TEMPORARY CHANGE T-4 to TECHNICAL MANUAL for RADIO RECEIVING SET AN/WRR-2A, AN/FRR-59A, NAVSHIPS 0967-137-3010 (Formerly NAVSHIPS 94715).

TEMPORARY CHANGE T3 TO TECHNICAL MANUAL FOR
RADIO RECEIVING SETS AN/WRR-2A & 2B and AN/FRR-59A & 59B
NAVSHIPS 94715

TEMPORARY CORRECTION T2 TO TECHNICAL MANUAL FOR
RADIO RECEIVING SETS AN/WRR-2A AND AN/FRR-59A
NAVSHIPS 94715

TEMPORARY CORRECTION T1 TO TECHNICAL MANUAL FOR
RADIO RECEIVING SETS AN/WRR-2A AND AN/FRR-59A
NAVSHIPS 94715

Figure T2-2. Corrections to figure 4-37, page 4-32

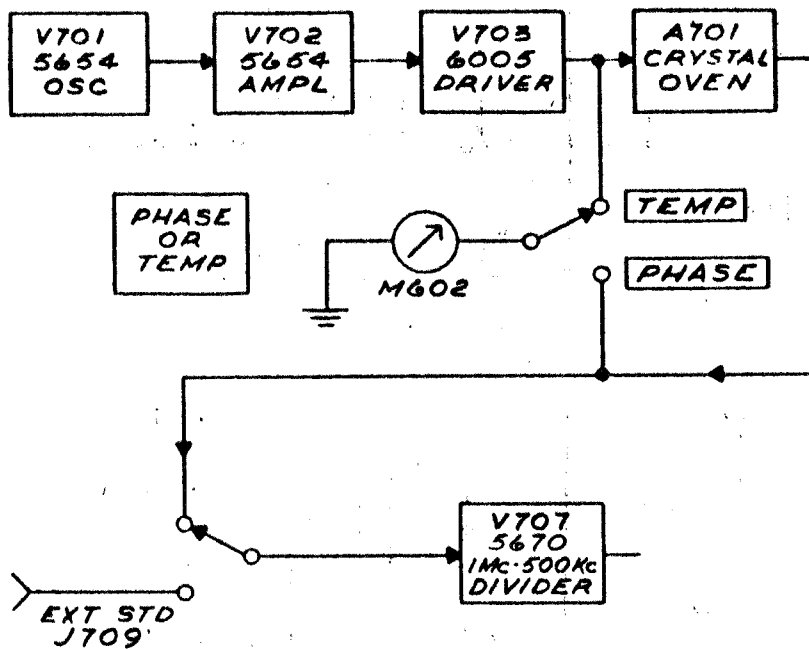
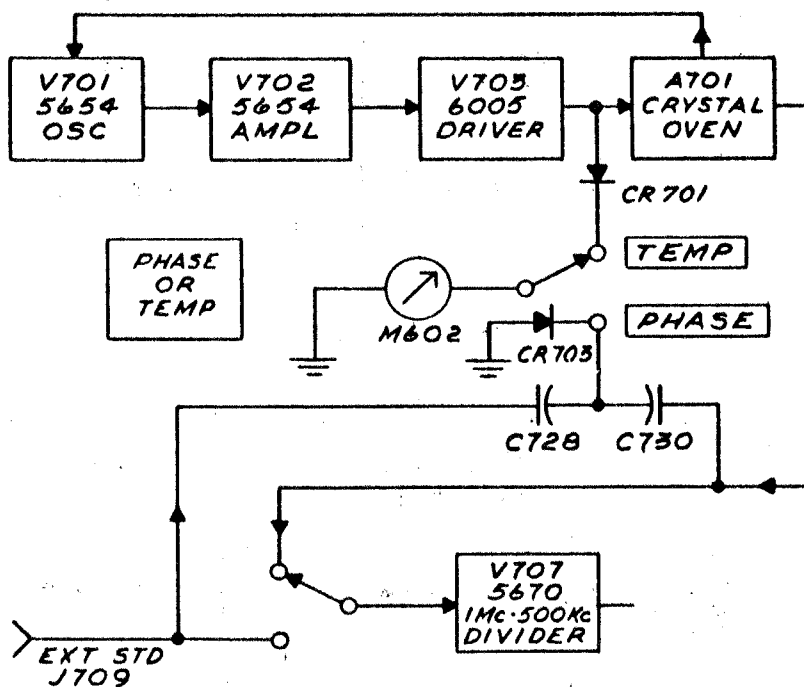
INCORRECT

CORRECT
